THE PORT AUTHORITY OF NEW YORK & NEW JERSEY

To: Mr. L. Menno, Manager, Contract Tenant Services Division, WT&EDD
From: Ennala Ramabhushanam
Date: November 22, 1991
Subject: **WTC - ALTERATION APPLICATION W-4636 - CEDEL, S.A. - 1 WTC - 90TH FLOOR - GENERAL CONSTRUCTION**

Reference: Review Request dated 11/13/91

DRAWING NO.: CSK-01

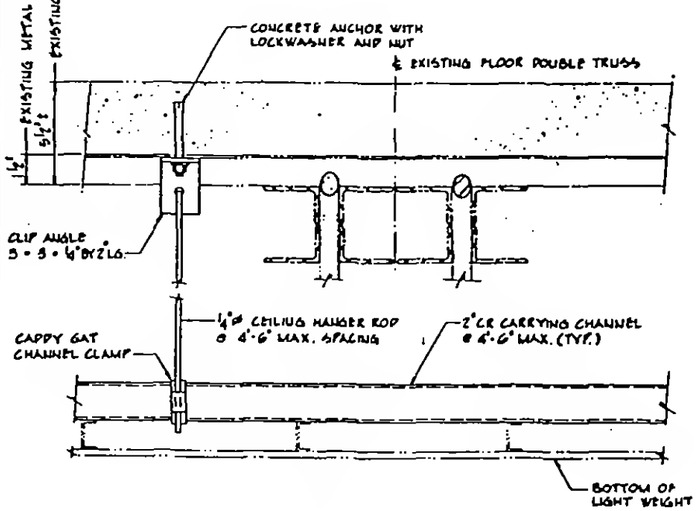
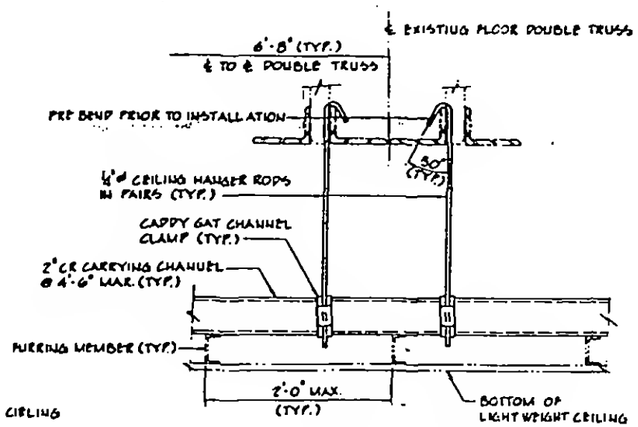
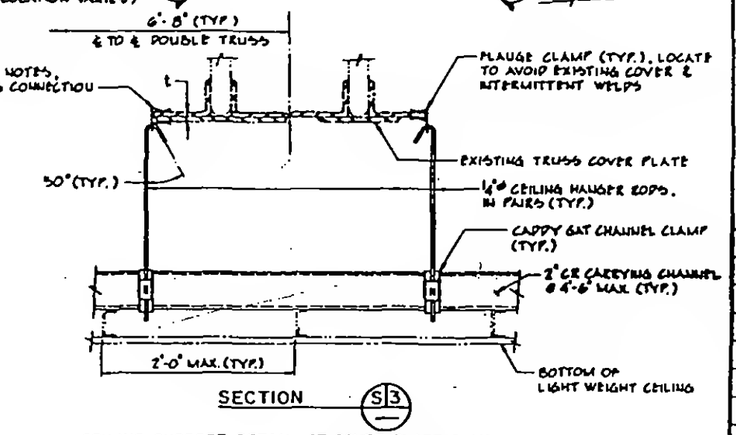
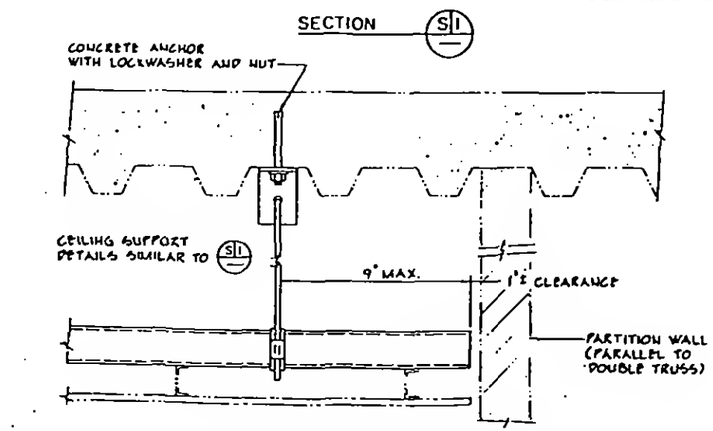
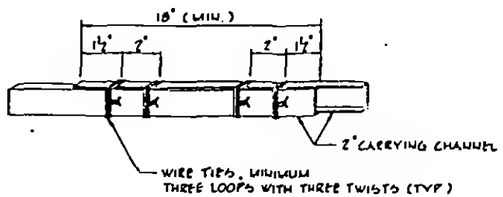
3. Dwg. A-3, "Typ. Lay-in Acoustical Tile Ceiling," Dwg. A-8, Section D. The ceiling support system shall agree with PANYNJ Dwg. S-1, "Lightweight Ceiling Support System, 1 WTC and 2 WTC." Please revise and submit for review. (Modified Repeat Comment) See Attachment.

DRAWING TITLE: STRUCTURAL CLG SUPPORT DETAILS
